REV <b>C</b>	trans-matic 300 East 48th Street Holland, MI 49423	TOLERANCES UNLESS OTHERWISE SPECIFIED - ENGLISH (METRIC) .XXXX = ±.0003 (1.0076) .XXX = ±.005 (1.27) .XX = ±.015 (1.38) ANGLE = ±1°	SIZE <b>A</b>
MAT'L	O1 Rc 50-52		
NAME	BLOCK, DIE BLOCK REAR HOLD DOWN

DATE <b>06-12-97</b>	SCALE <b>3/4</b>
DWN. BY <b>TCB</b>	CAT-SUB <b>551-016</b>
CHECKED BY	PAGE <b>1 OF 1</b>
DWG NO. <b>551-225681</b>

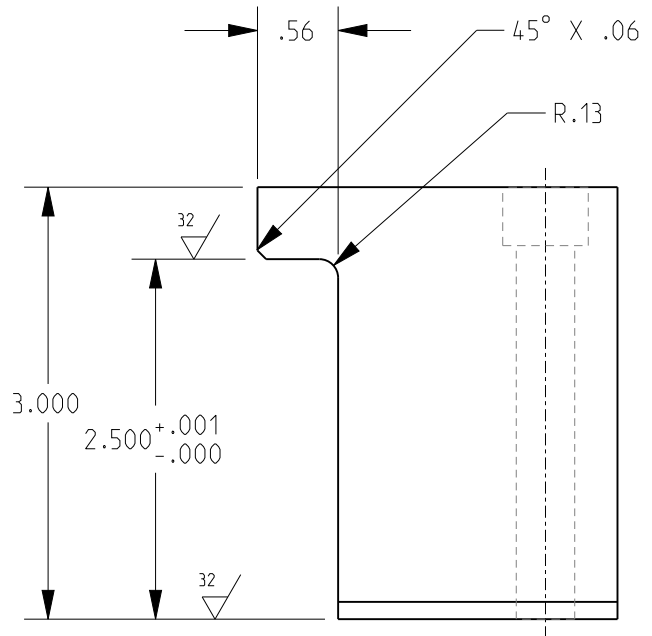
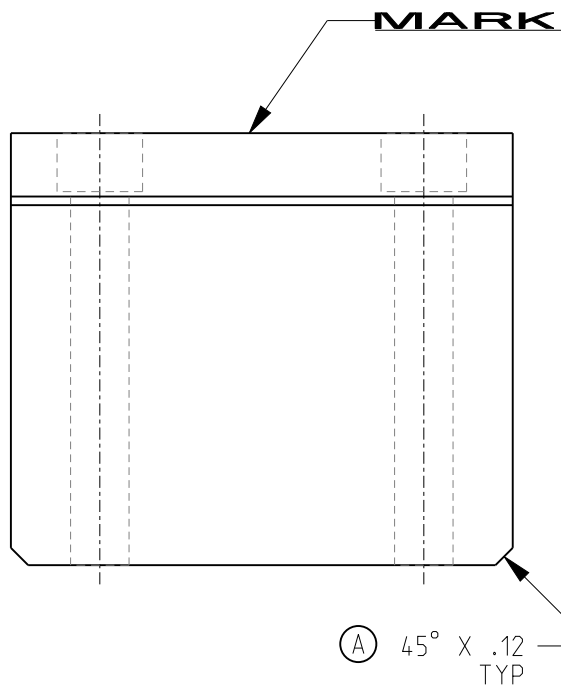
MODEL & DETAIL IN PRO-E. 3.485 WAS 3.499 +.000/- .001. ADD .12 CHAM. SEE OBS FOR PREVIOUS REV'S	C	10-21-13 SMS
TCN#/CHANGE	LTR	DATE
